**BRONSON SLOPE MINE  
COPPER/GOLD PROJECT**

**DRAFT  
PROJECT REPORT  
SPECIFICATIONS**

**RE: Bronson Slope Application for a Project Approval Certificate**

**FROM: Paul Wojdak, Regional Geologist (File W:\PWojdak\Br\_Slope.doc)**

Figure  
**2-1**

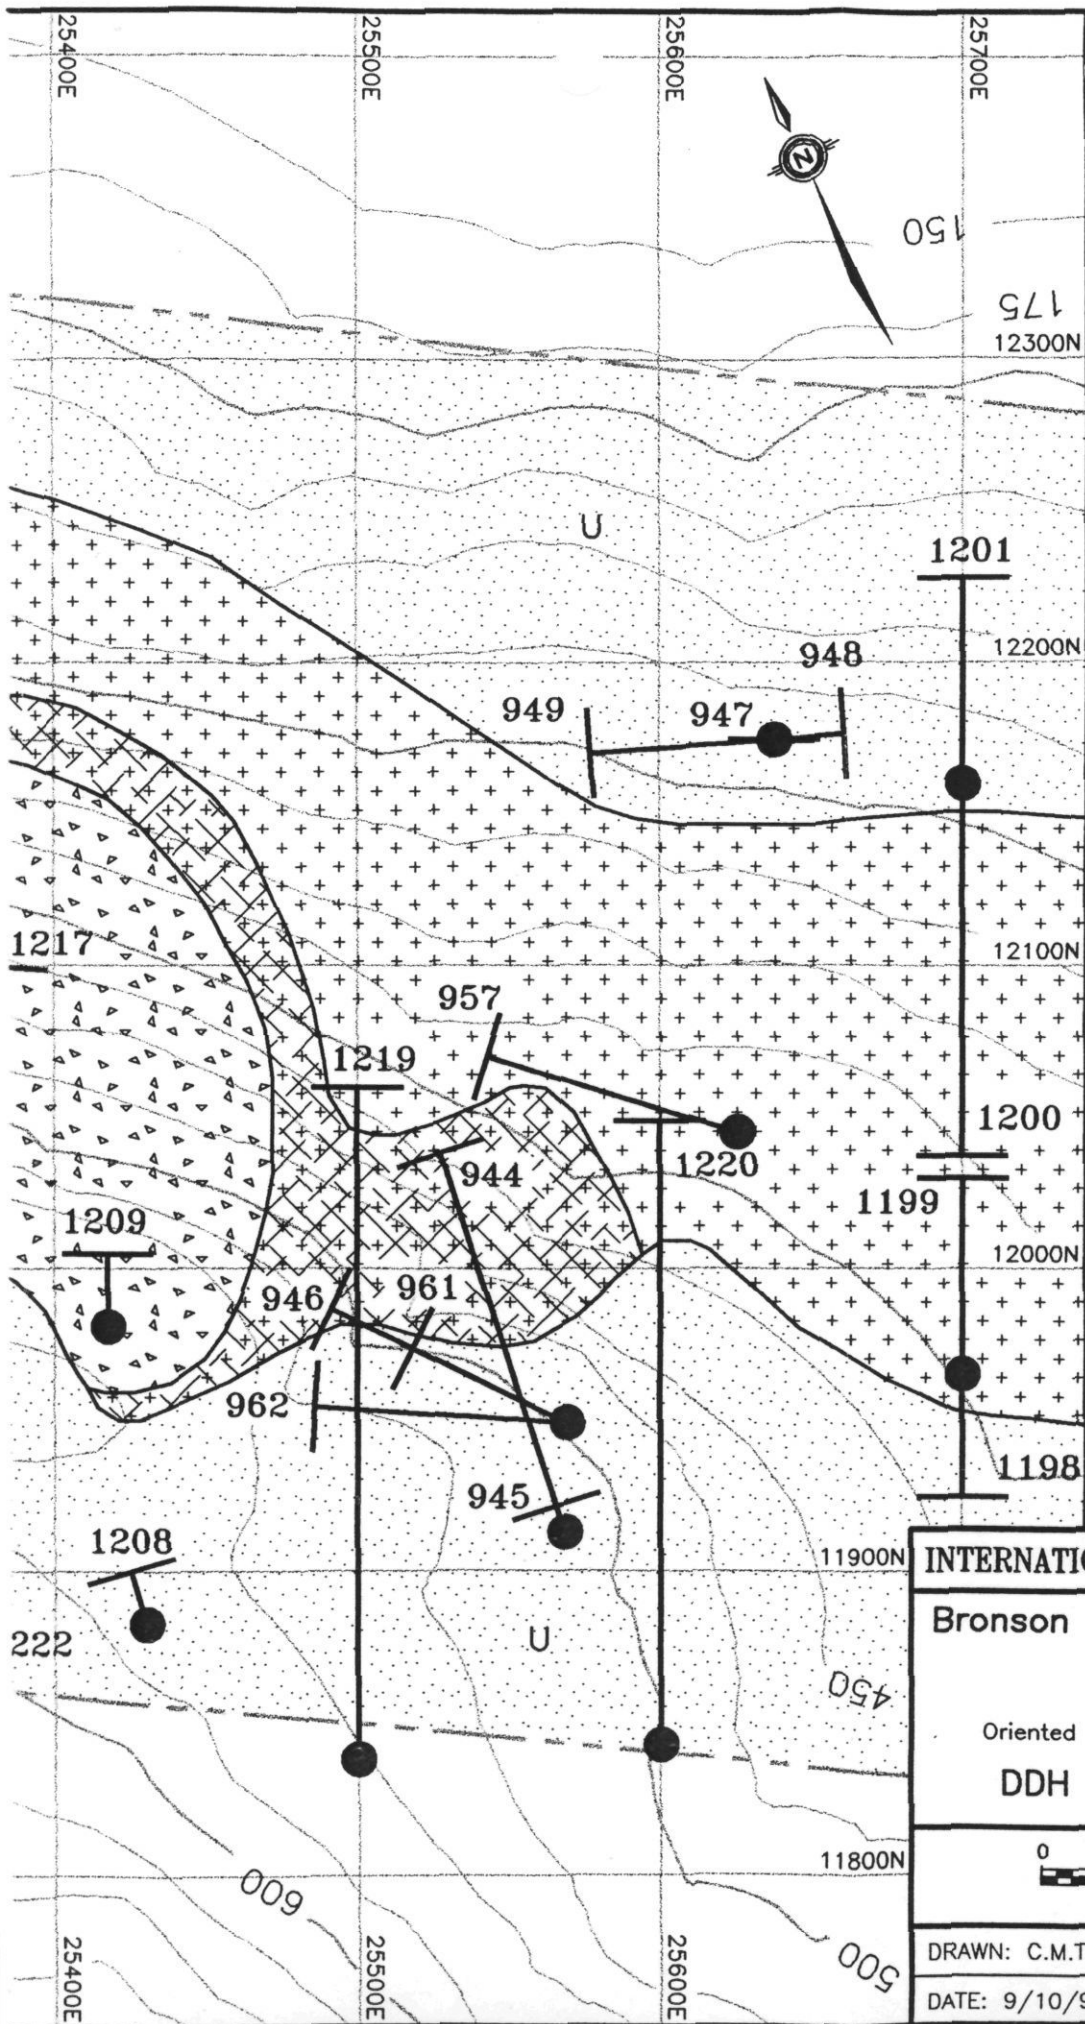
- The drill hole data base is extremely small to confidently estimate a mineral resource. The application states there are 47 holes, totalling 7126 metres of drilling but just 35 holes are shown on Figure 2-1. By my experience and professional judgement at least 20,000-30,000 metres of drilling is required to define a "Probable" ore reserve on a 100 million tonne porphyry deposit in which gold is the primary economic commodity. The present drill density is sufficient for only a "Possible" ore reserve.

- Drill sections across the Red Bluff stock are spaced 50-100 metres apart with only 1-3 holes per section (Figure 2-1). Section spacing should be no greater than 50 metres, and possibly less if grade correlation between sections is poor, with at least 3-4 holes per section.

- The stock is elongated northwesterly and it is likely the quartz-magnetite-chalcopyrite stockwork is oriented parallel to it. If so, drill holes should be drilled across the stock to test mineralization properly. Many holes are drilled parallel to the Red Bluff stock (eg. 949, 957, 964) and may not provide good information. The possibility of preferred vein orientation should be addressed.

Sufficient drilling should be carried out to estimate ore reserves. The proponent should provide verification of Bronson Slope ore reserves by an independent consultant that has a well established record of acceptability in the mining industry.
